# United States Department of the Interior

RE: Soldier Canyon Mine Resource Recovery and Protection Plan  
(R2P2) Modification, 3rd West Pillars Section

SOLDIER CREEK COAL COMPANY  
SOLDIER CANYON MINE  
ROCK CANOYN SEAM  
APPROVED MINE MAP

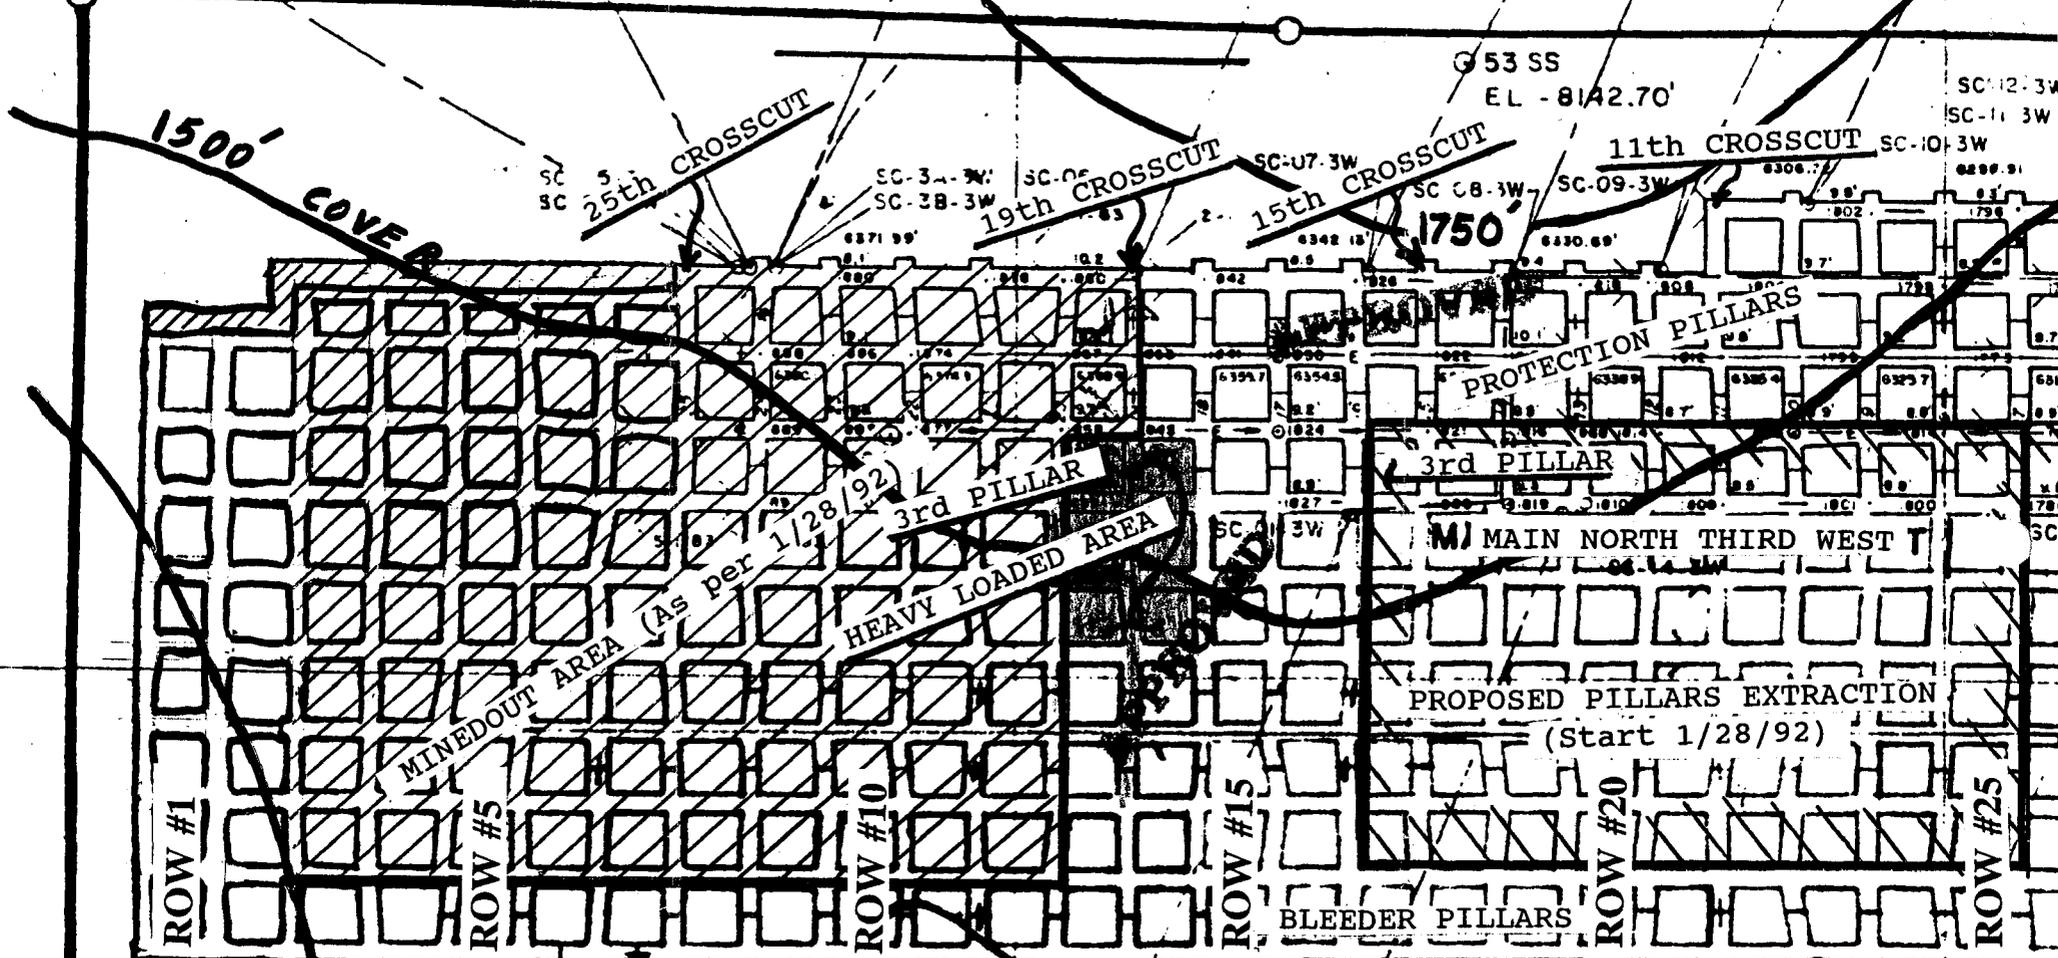
The approved plan for pillar retreat mining in the 3rd West Pillars section was to mine pillar rows from west to east with each row consisting of eight pillars. One pillar in each row was left on the south side for a bleeder. Presently, the continuous miner is mining in the 3rd pillar of pillar row #13 inby the 19th crosscut. Due to severe bouncing activities, the company proposed to abandon this row and the other three pillar rows to the east (rows #14 - #16). Starting with row #17, SCCC plans to pull only six pillars across the panel instead of the eight originally planned. This would leave two pillars on the north side and one pillar on the south side for protection and a bleeder (please see enclosure).

A file search indicated that this section was developed on 80X80-foot centers. A 9-foot mining height is presently being mined under 1250 to 1750 feet of overburden. A weak roof was encountered on development between the 11th and 25th crosscut which forced SCCC

to delete the north pillar at the 11th crosscut and reduce the pillar size at the 25th crosscut. Steve Falk, a BLM mining engineer from the Price Coal Office, inspected the mine on January 28, 1992. During the mine inspection, a major floor heave, roof fractures, severe rib bursts and pillar failure were observed along the 19th crosscut. A sandstone top of 5 to 10 feet of weak laminated roof was also observed behind the mined-out pillars. A discussion with a SCCC mining engineer indicates that the company is in close communication with a rock mechanics engineer at U. S. Bureau of Mines (Spokane Office) regarding this matter. Independent calculations conducted by Abe Elias, BLM engineer, indicate that pillar sizes on 80X80-foot centers is marginal for 1500 to 1750 feet of cover, even with fair geologic conditions.

The combination of a shale roof, the sandstone formation above the shale, and marginal pillar sizes have created an unsafe condition. The proposed plan of leaving three complete rows and one partial row (30 pillars) should be an adequate barrier to support the overriding stresses. Leaving two pillars on the north side will move mining activities to a location under lower overburden as additional precaution against further bounces. Under the present circumstances, Price Coal Office personnel agree with this proposal to abandon these pillars to reduce safety risks to the mining crew. Geologic study and adequate pillar design by SCCC is strongly encouraged in the future to ensure maximum economic recovery.

BLM has determined that the mine plan change is in compliance with the Mineral Leasing Act of 1920, as amended, the regulations at 43 CFR 3400, the lease terms and stipulations, and will achieve maximum economic recovery of the Federal coal. Therefore, the BLM will allow the mine plan change. This confirms the verbal approval given to Soldier Creek Mine personnel on January 28, 1992. An estimated 58,000 tons of coal reserves will now be deemed unrecoverable. A copy of the approved mine map is enclosed.

MINOR MODIFICATION TO  
MINING PLAN APPROVED BY  
BUREAU OF LAND MANAGEMENT
